IREDELL COUNTY HEALTH DEPARTMENT

SEPTIC IMPROVEMENT PERMIT / AUTHORIZATION TO CONSTRUCT / OPERATION PERMIT / EXISTING SYSTEM M-AtD.

SITE ADDRESS: 100 Peninsula Dr. Mooresville, NC | PHONE: 704-578-4951 (Kathleen) | ALT PHONE: ——

100 Penninsula Drive Fast Track Septic Spec Sheet

AS BUILT SKETCH

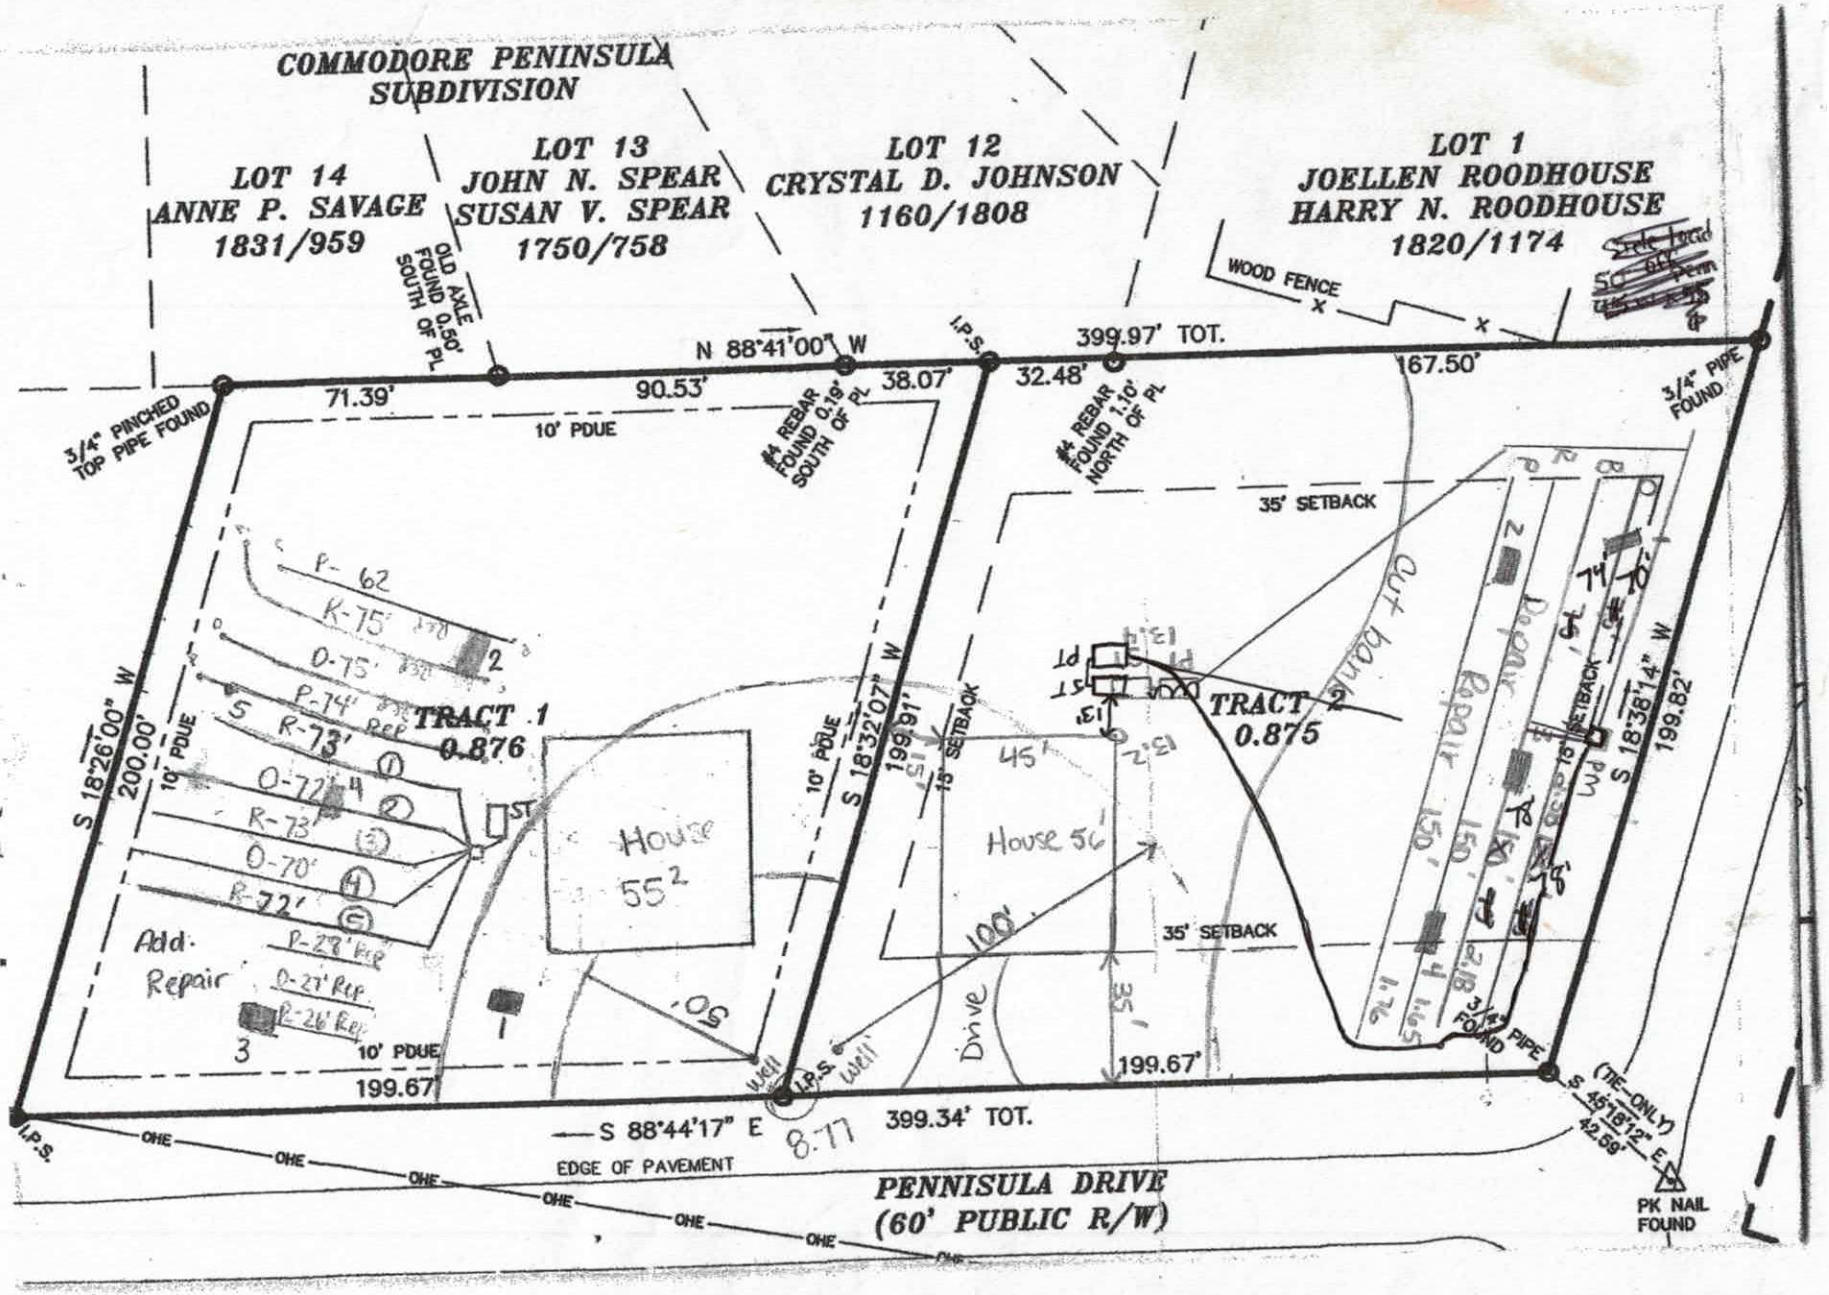
Date	Initials
Drain Lines Checked	6-19-18	KW
Tanks Checked	6-19-18	KW
Pressure Manifold or Valve Box Checked		
Pressure Head Set	3/29/A	MD
Electrical Checked	3-27-19	JS
Floats Set	3-27-19	JS
Alarm Checked	3-27-19	JS
Maintenance Contract Y / N	N/A	
Comments: 6-20: supply line checked NOT approved until front property line is re-surveyed. supply line appears to be less than 5' or off property. KW supply line may have to be relocated

3-27-19 Supply line was 3' from prop line and must be moved. Pressure manifold is 7' from prop line and must be moved. JS

PM - 1 Pt to PL, Supply line 6 ft to PL at closest pt. Set 2 ft pressure head. 3/29/19

Installed by: Gunter Grading / Steve Jordon (Supply line moved 3/29/19)
